A303 Amesbury to Berwick Down

Proposed Changes Consultation Booklet

July 2019

Proposed Changes Consultation Booklet – Correction Sheet

Figure 8-1 Extract from Rights of Way and Access Plans [APP-009]

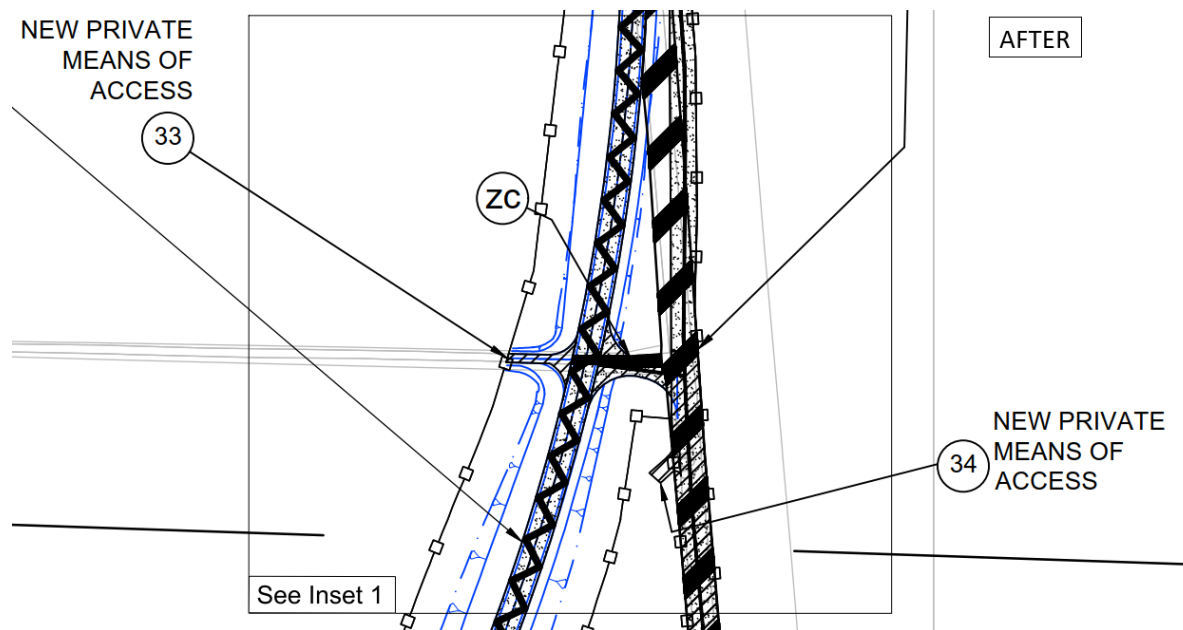
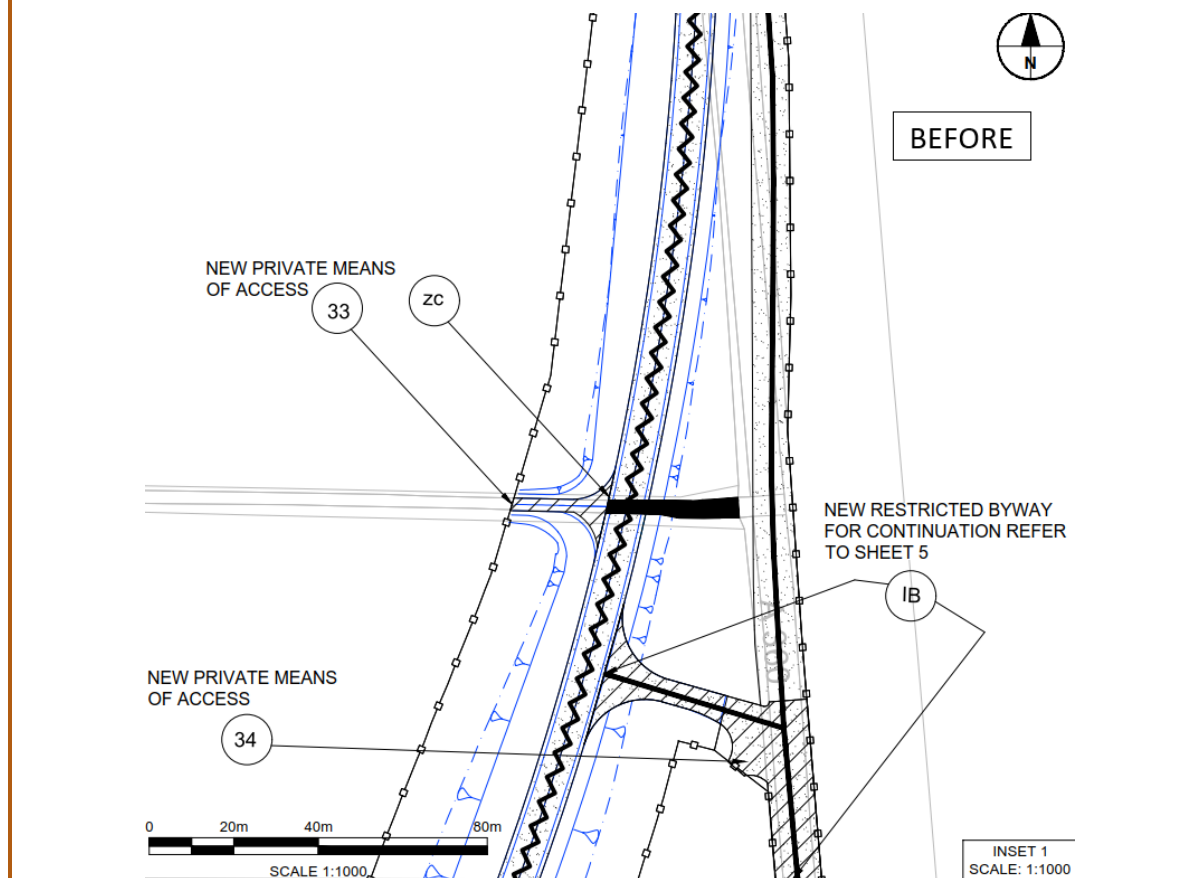
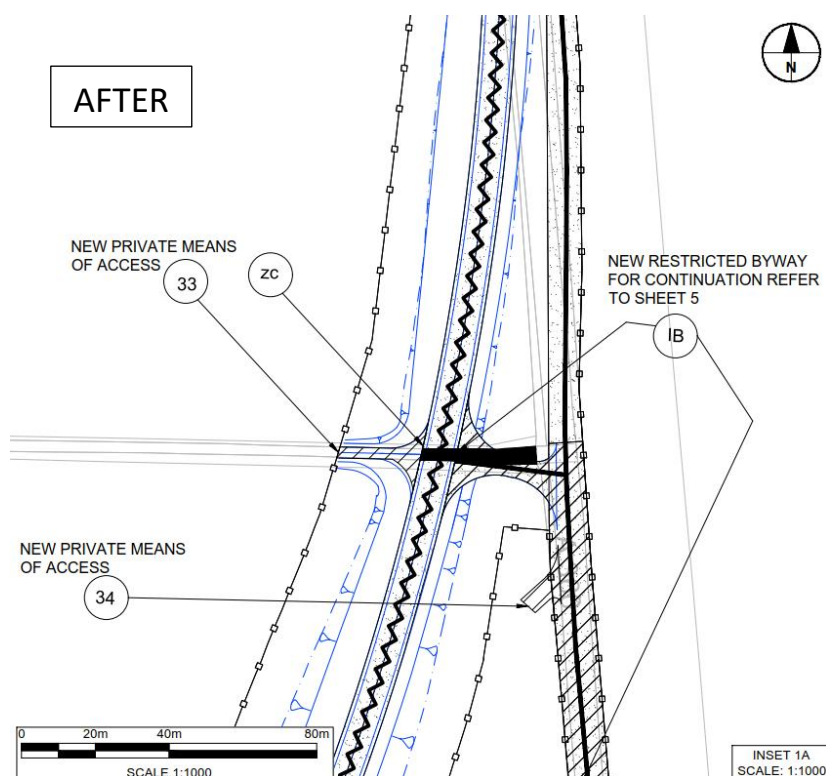
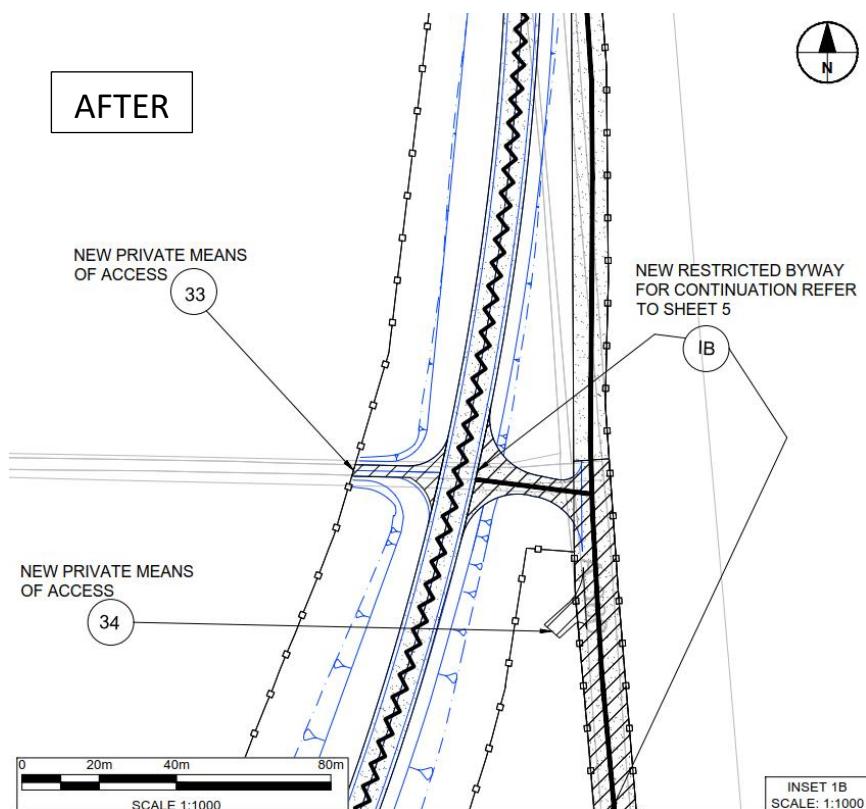
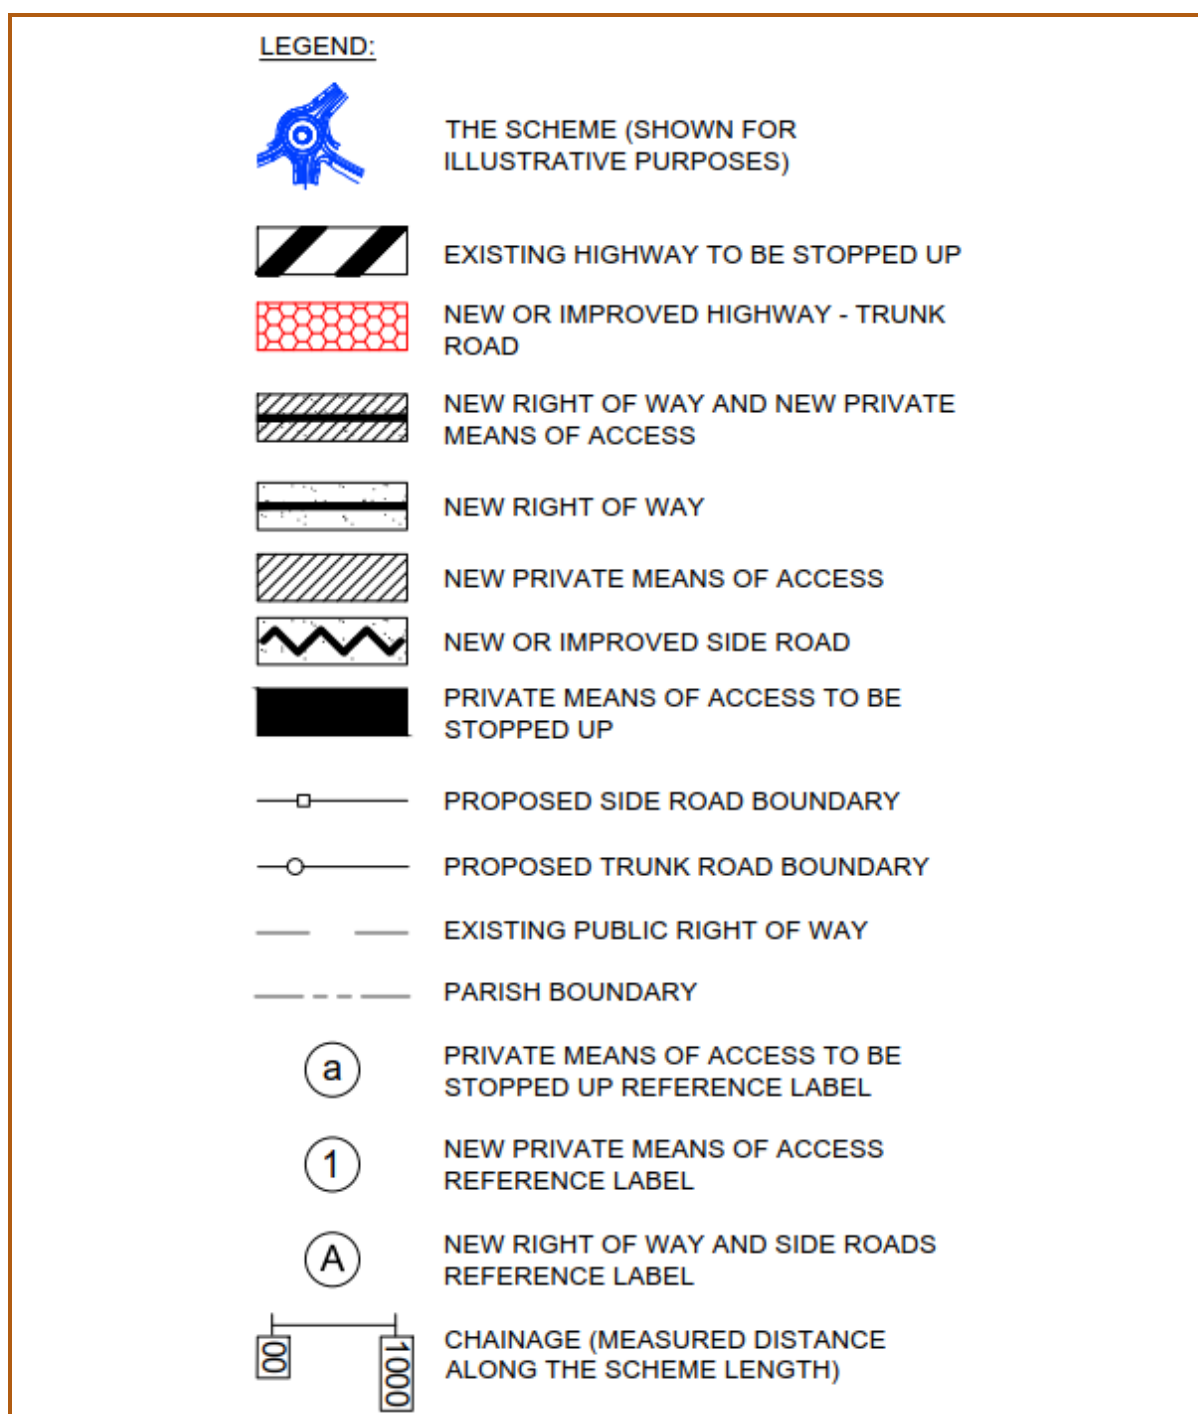
- 8.2.1 The proposed change includes an amendment to the proposed link between the realigned A360 north of Longbarrow roundabout and the new restricted byway, which would involve the link being moved northwards by approximately 45 metres.
- 8.2.2 As the excerpts from the Rights of Way and Access Plans [APP-009] show in Figure 8-1 below, the new proposed field access would replace the current layout between the realigned A360 north of Longbarrow roundabout and the new restricted byway. The proposed field access would be relocated to the north of the location currently shown on the Rights of Way and Access Plans and the General Arrangement Drawings (Sheet 14 of 15).

- 8.2.3 The proposed change would need to be added to the Rights of Way and Access Plans (sheet 14 of 15, including the addition of revised Inset 1A and new Inset 1B on that Sheet) [APP-009]. It would also require a minor amendment to the corresponding drafting in Part 3 of Schedule 3 to the draft Development Consent Order [REP4-018] where the location of the proposed link is described.
- 8.2.4 This proposed change would only require the use of land which is already within the Order limits and proposed to be acquired compulsorily; it would not require any 'additional land' as defined in the Infrastructure Planning (Compulsory Acquisition) Regulations 2010 ('CA Regulations') and would therefore not engage the CA Regulations.

Sheet 14 of 15 - Excerpt showing original proposal with existing field access being stopped up and replaced by new offset link to PMA 33

Sheet 14 of 15 - Excerpt showing revised proposal with new field access on a more direct alignment (similar to the stopped up access) and leading more directly to PMA 33

Sheet 14 of 15, Inset 1 - Excerpt showing original proposal with existing field access being stopped up and replaced by new offset link to PMA 33

Sheet 14 of 15, Inset 1A - Excerpt showing revised proposal with new field access on a more direct alignment (similar to the stopped up access) and leading more directly to PMA 33

Sheet 14 of 15, new Inset 1B - Excerpt showing revised proposal with new field access on a more direct alignment (similar to the stopped up access) and leading more directly to PMA 33

Figure 9-1 Extract from General Arrangement plans legend [APP-012] with proposed additions

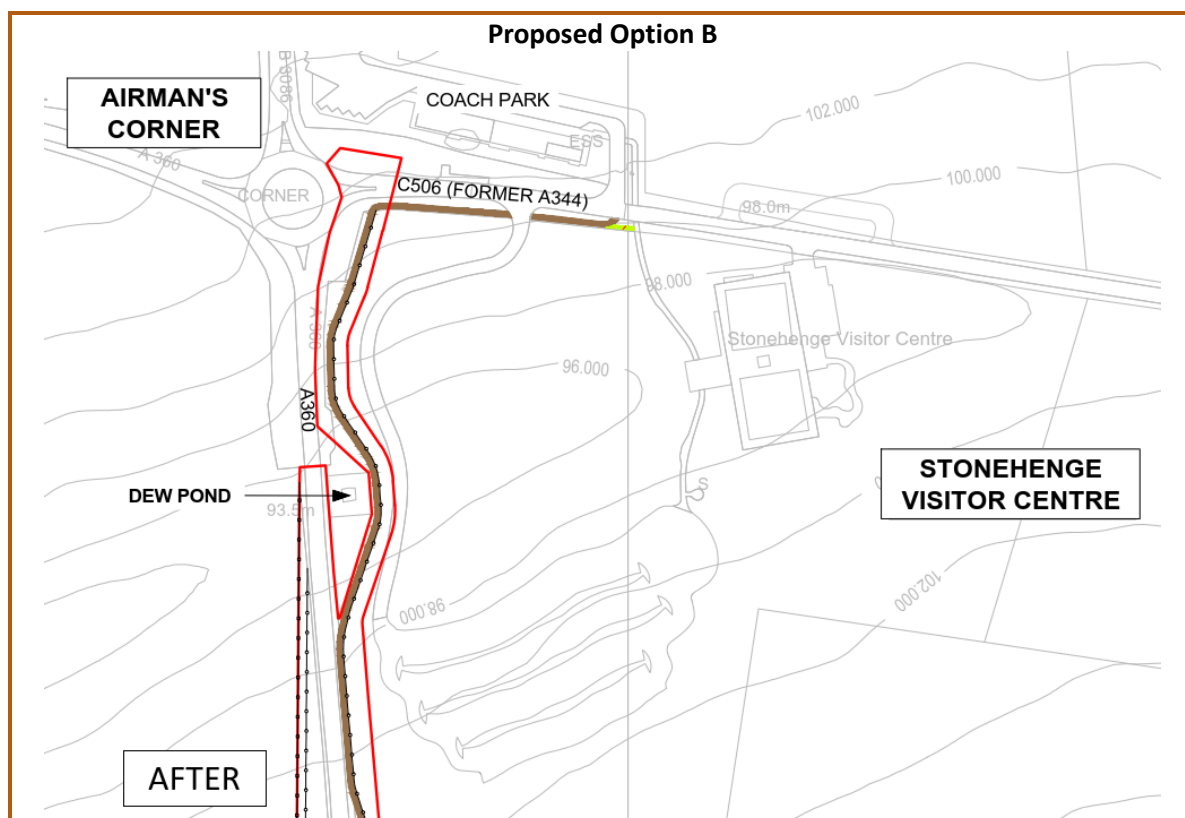
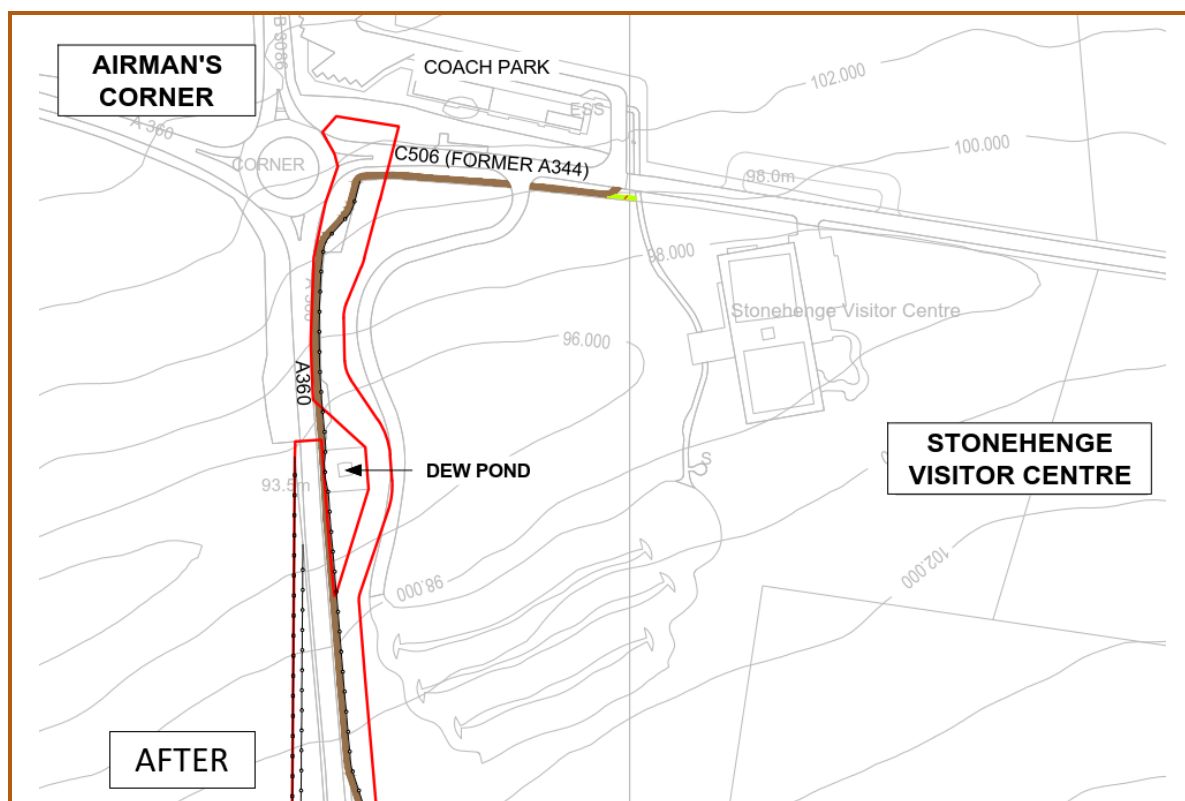
- 9.2.4 Option B is generally the same as Option A, except that the path would be 2.5 metres wide along its entire length and would pass to the east of the Dew Pond. **This part of** Option B could be delivered within the Order limits; ~~Option B~~ **Option B** would not require any additional land outside the Order limits **except for the area alongside the former A344.**

- 9.2.5 ~~Option A~~ **NMC-06** is subject to Highways England being able to secure the necessary additional land (currently outside the Order limits) by agreement. As mentioned above, Highways England does not wish to engage the Infrastructure Planning (Compulsory Acquisition) Regulations 2010 to acquire the additional land compulsorily. Therefore, if the additional land cannot be secured by agreement with the landowners within the necessary timescale, Highways England would withdraw its application for proposed **NMC-06** ~~Option A~~.

- 9.2.6 Alternately, if the additional land required for Option A is secured by agreement within the necessary timescale, Highways England would withdraw its application for proposed Option B **and vice versa.**

- 9.2.1 Highways England's proposed change relates to the section of proposed restricted byway next to the A360, where it runs northwards from the southern boundary of the Stonehenge Visitor Centre (shown on Sheet 14 of the Rights of Way and Access Plans as reference UA [APP-009]. The restricted byway proposals would be changed to a shared-use cyclepath, 2.5 metres wide ('path'). There would be a minimum 1 metre wide verge between the existing carriageway of the A360 and the path, and a minimum 0.5 metre wide verge between the path and the boundary fence with the Stonehenge Visitor Centre. The alignment of the boundary fence would be

- 9.2.2 As the following excerpts from the General Arrangement Drawings [APP-012] show, two options (A and B) have been developed. In both Options A and B, the path would be located on the eastern side of the existing A360 running northwards to Airman's Corner and then extending eastwards along the southern verge of the C506 (the former A344). Options A and B are shown in Figure 9-1 below.
